Report: Deficiency Report
Function: Test, Adjust, & Balance
Date: 02/12/2025
Completed By: National TAB

PROJECT
02-10-25 WAWA #5459 STARKE, FL

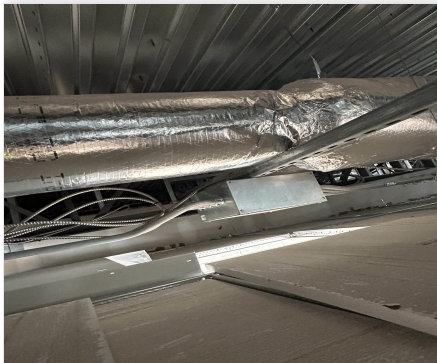
Issue Name : Diffuser 1-11 - No Damper
Description : Damper is missing or could not be located for diffuser 1-11 (retail area). Recommend mechanical inspection.
Created By : National TAB **Assigned To :** National TAB - Dan Hertenstein
Status : Open
Priority : Urgent **Asset Tag :** SGRD11
Originated Date : 02/12/2025 - Mark Johnson - National TAB

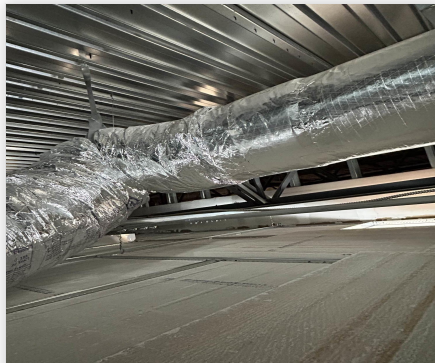
Issue Name : Diffuser 3-1 - No Damper
Description : Damper is missing or could not be located for diffuser 3-1 (front vestibule). Recommend mechanical inspection.
Created By : National TAB **Assigned To :** National TAB - Dan Hertenstein
Status : Open
Priority : Urgent **Asset Tag :** SGRD1
Originated Date : 02/12/2025 - Mark Johnson - National TAB

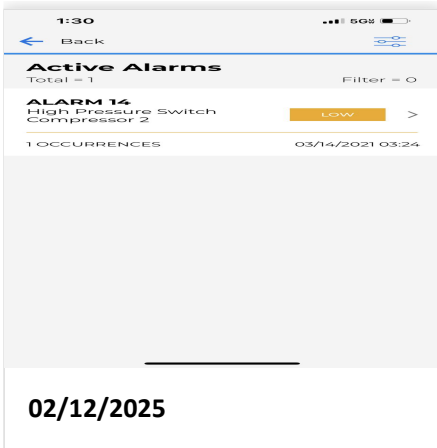
Issue Name : RTU 1 - Alarm 14
Description : RTU 1 is displaying Alarm 14 - High Pressure Switch Compressor 2. Compressor 2 is locked out. Recommend servicing.
Created By : National TAB **Assigned To :** National TAB - Dan Hertenstein
Status : Open
Priority : High **Asset Tag :** RTU1
Originated Date : 02/12/2025 - Mark Johnson - National TAB
